Our Ref: R/2019/20/E
File No: 2021/561165
Your Ref: SSD-10384-Mod-1

SSD 10384 MOD 1 – Removal and replacement of 2 trees on Gloucester Walk – Advice on Response to Submissions

Figure 1 Alternative retaining wall construction

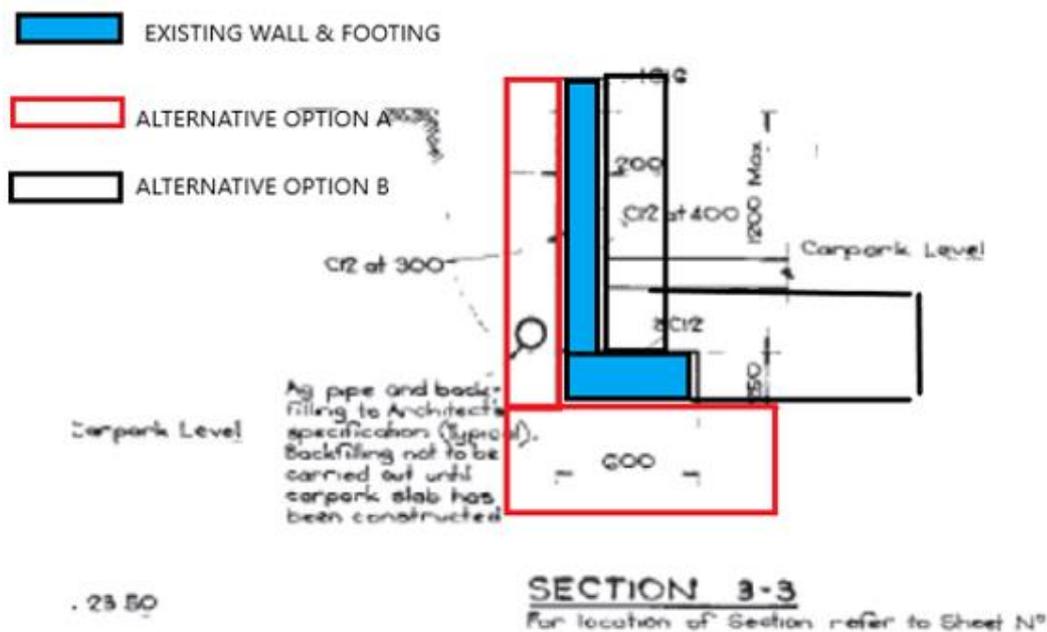
- 1) Constructing the new wall and footing in front of the existing wall and footing without the use of large machinery. The existing retaining wall would be maintained with a new retaining wall and footing located within the carpark. See Option B annotated on the image below (NB: drawing requires separate review by a qualified structural engineer).
